ADDENDUM

PROJECT NAME: Our Lady of Perpetual Help – Barrier Free Elevator Expansion

ADDENDUM NO.: PTA-E-01

1.1 Drawings E001, E002, E003, E004, E100, ED100 (Attached)

5 LIGHT FIXTURE SCHEDULE

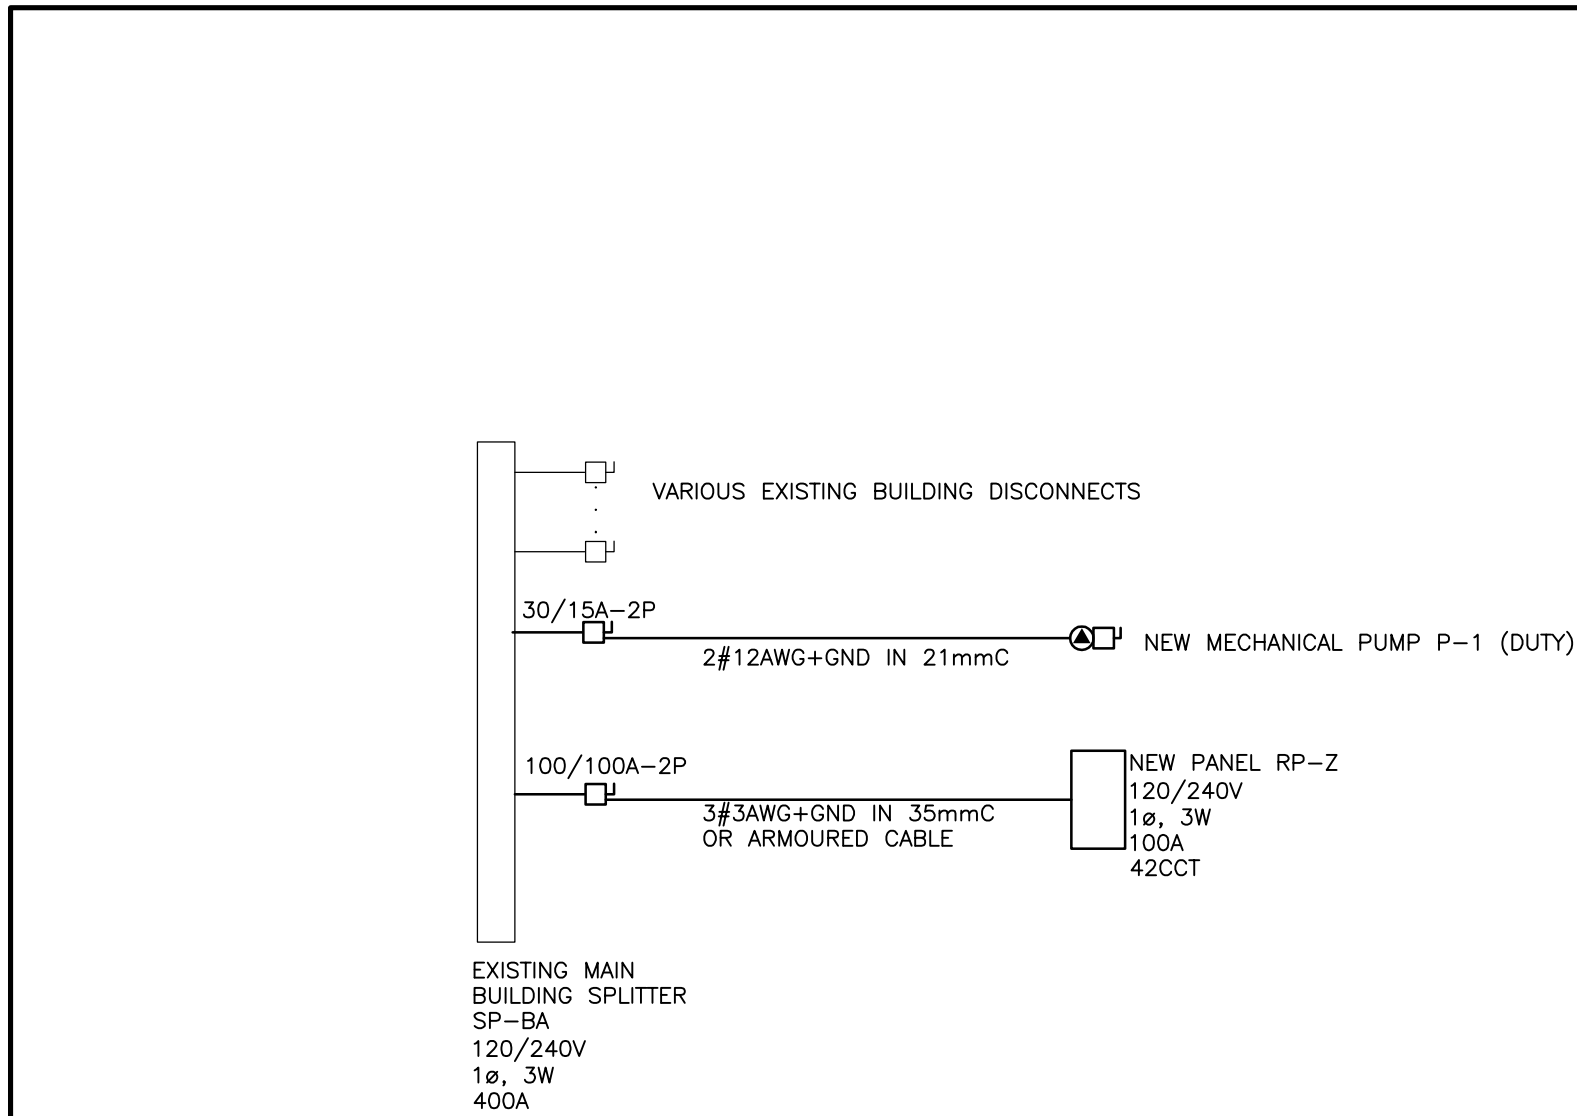
2.1 E001

2.1.1 Revise light fixture schedule as shown on drawing.

ELECTRICAL DETAILS

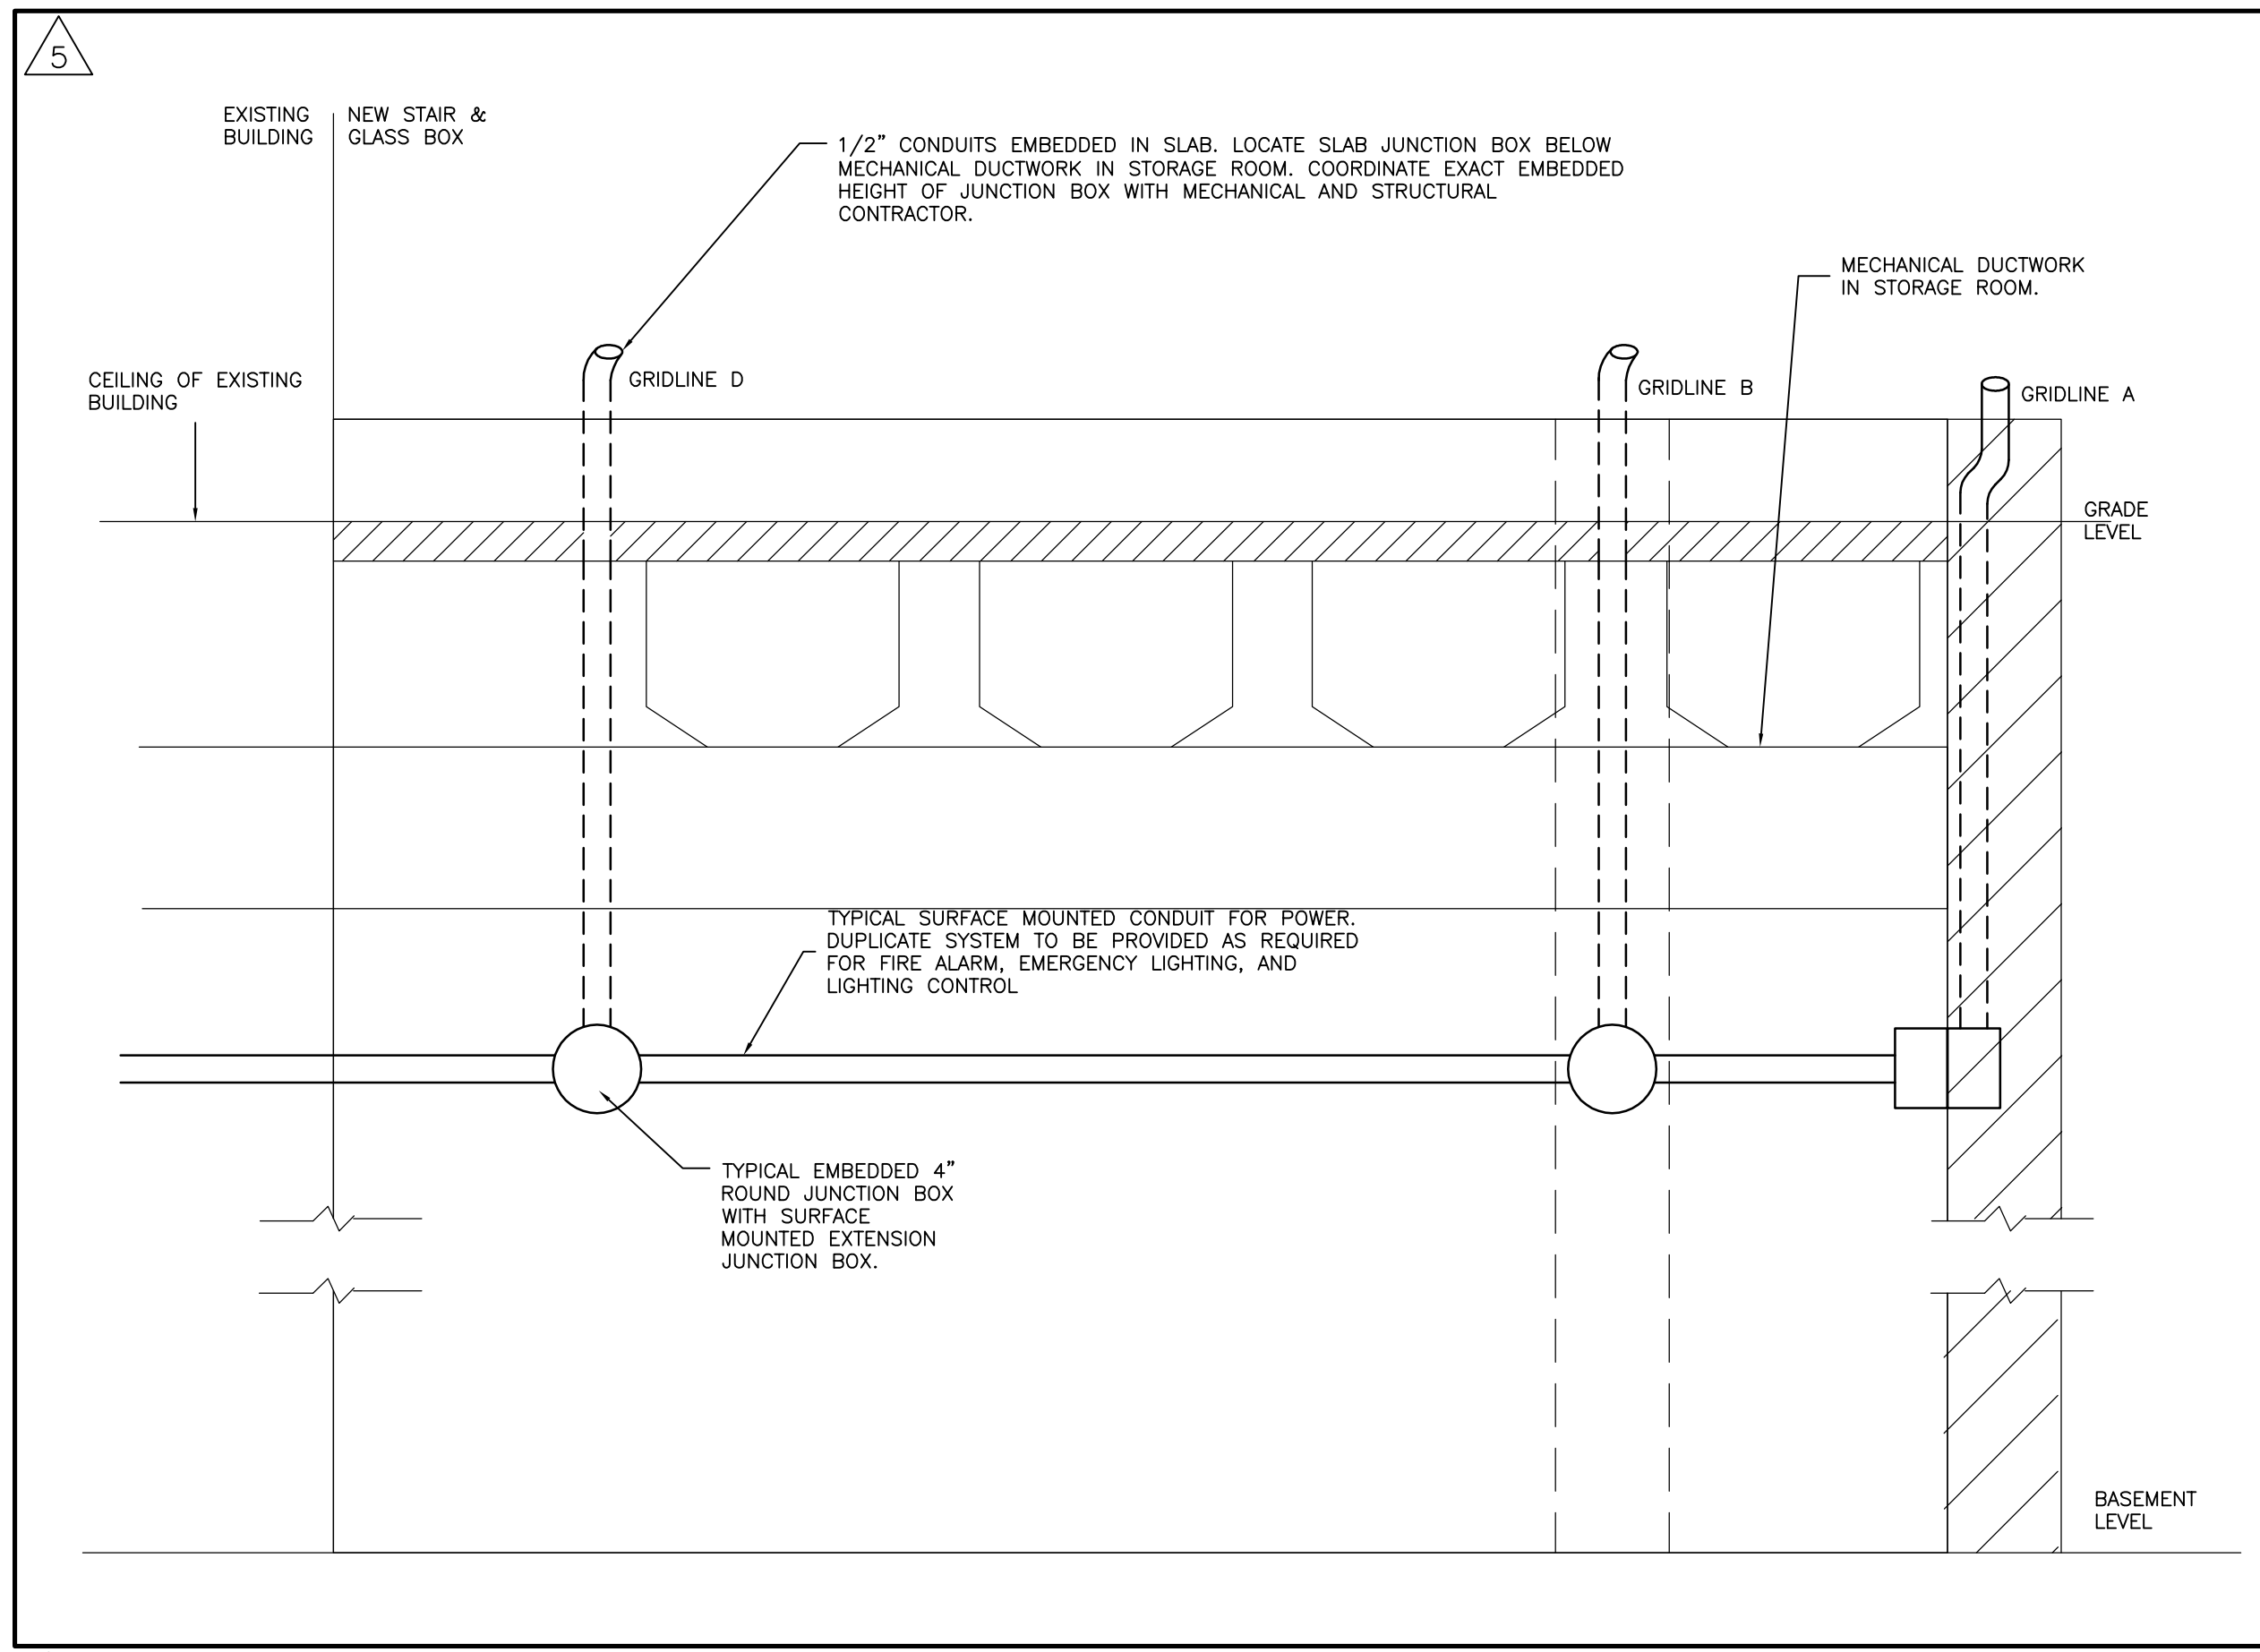
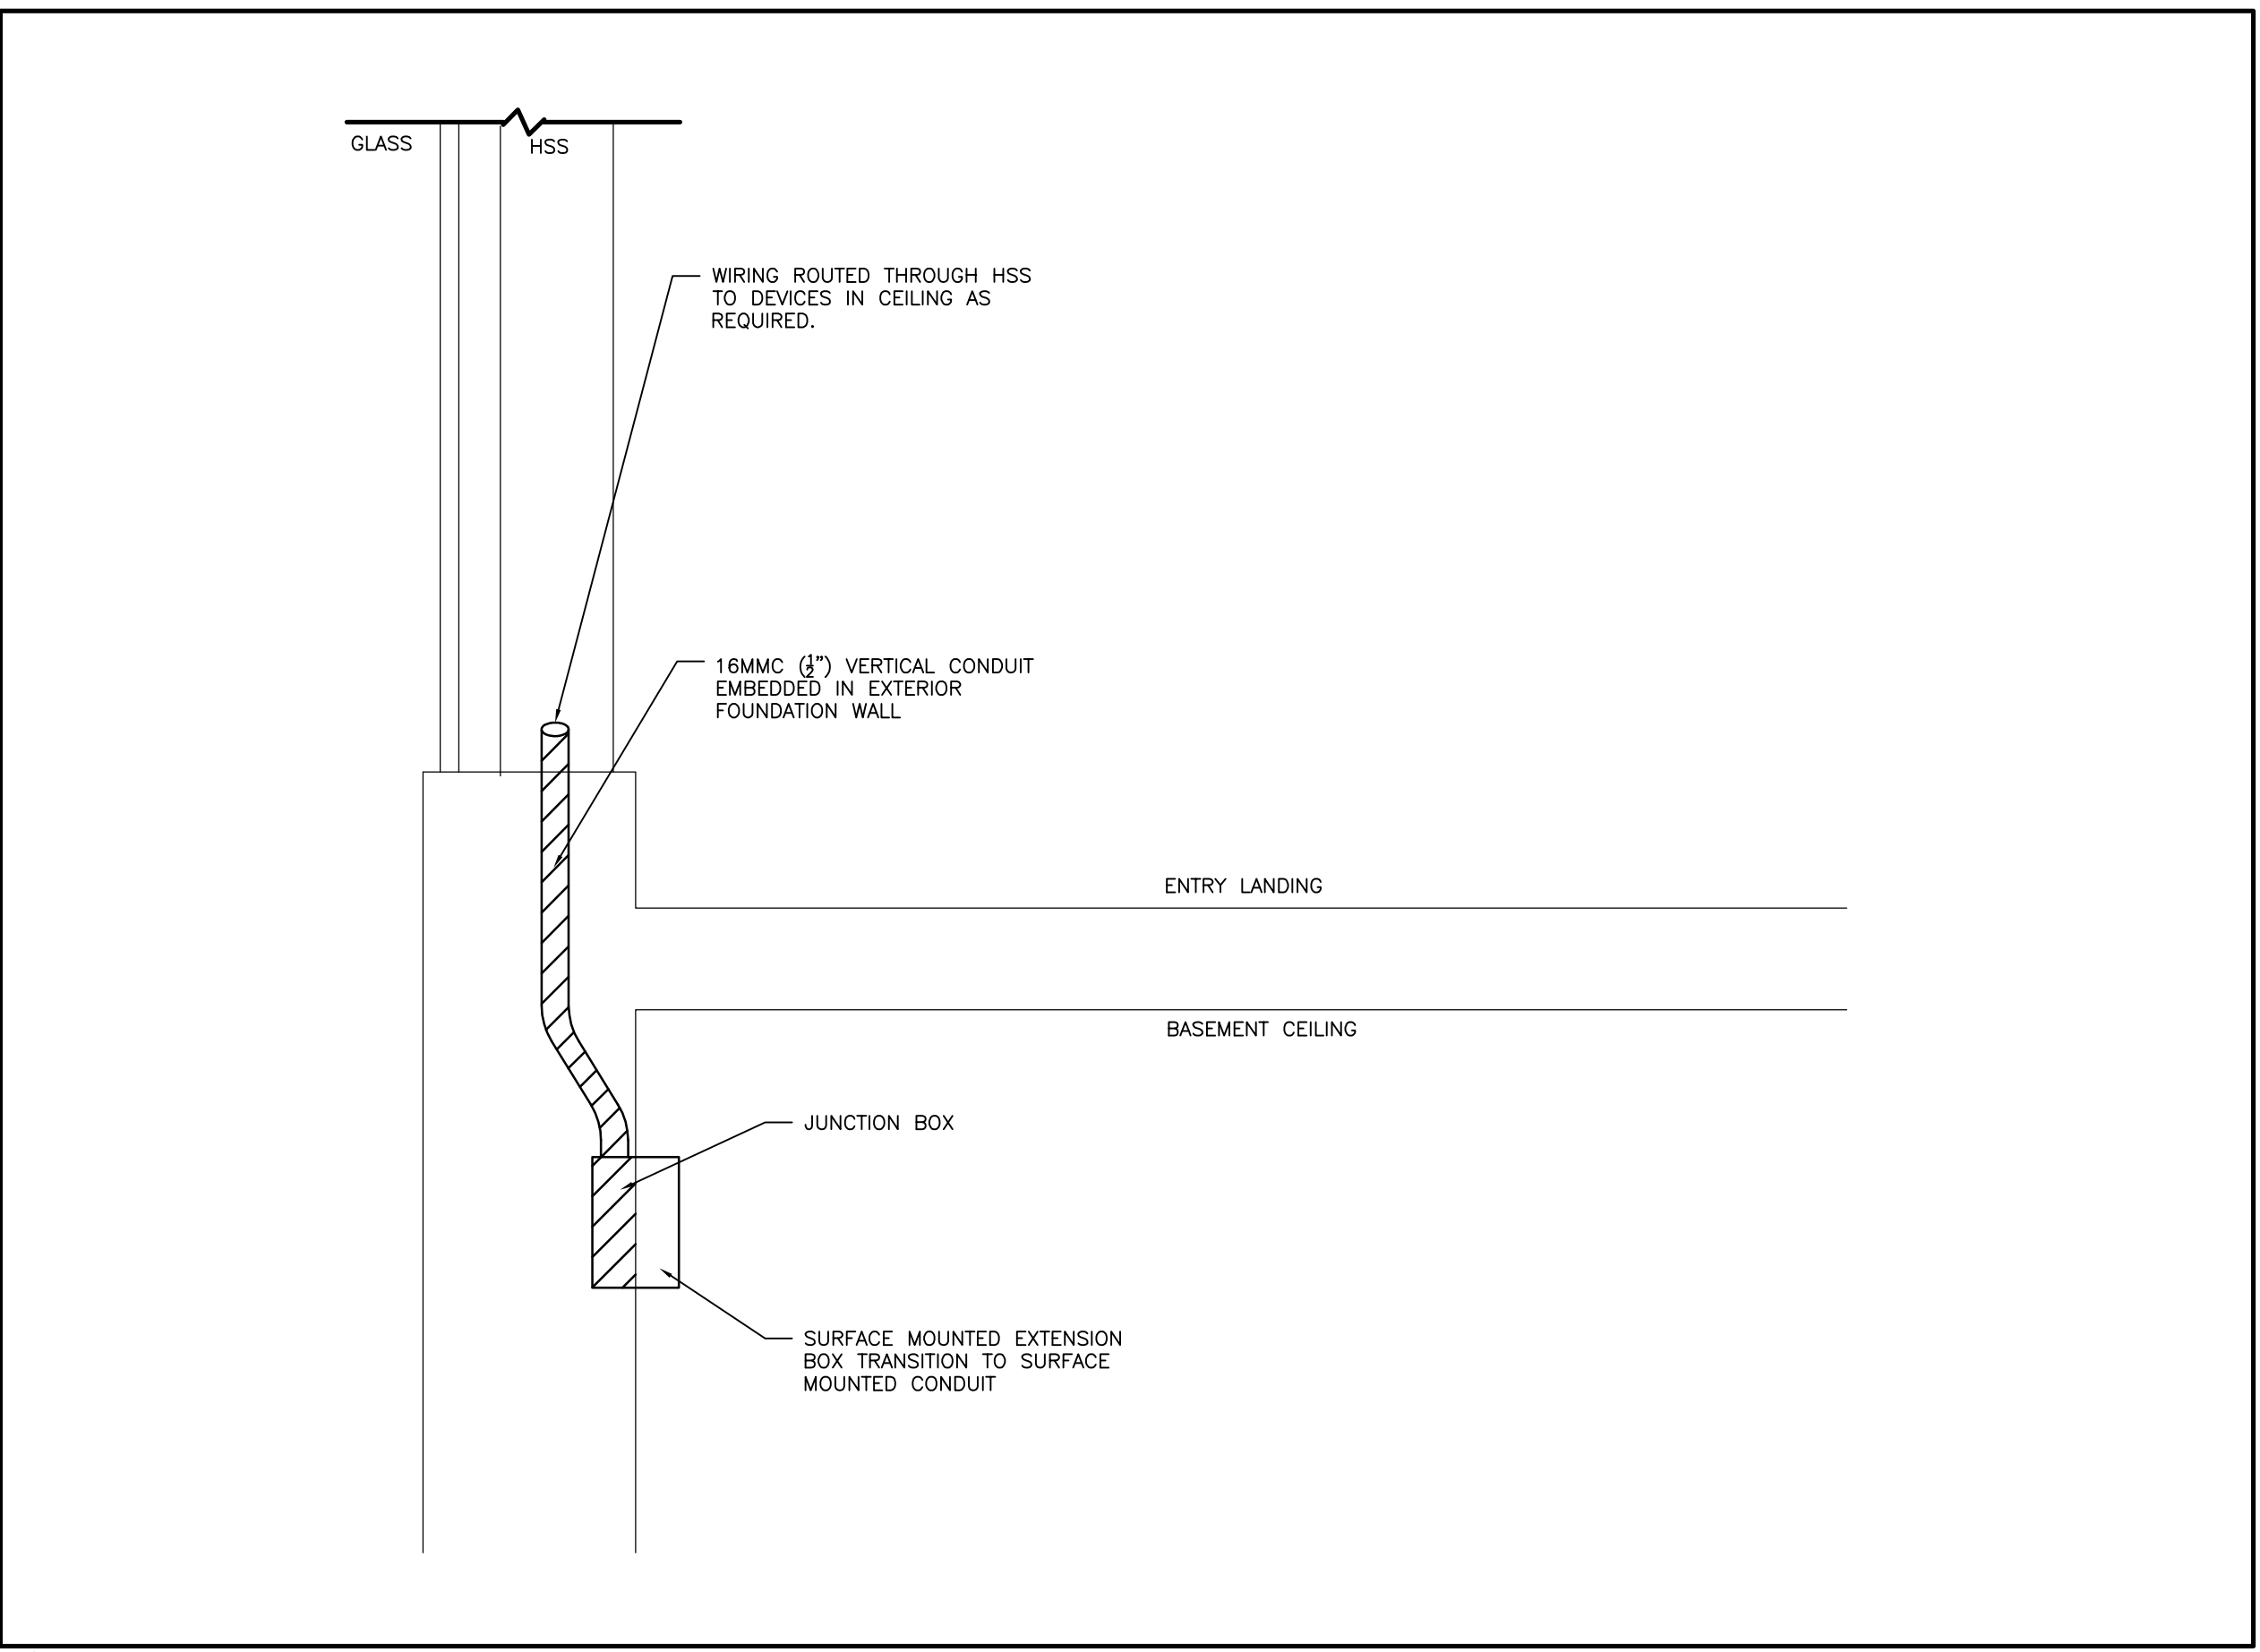
2.2 E002

2.2.1 Revise general intent of raceway routing through HSS as shown.
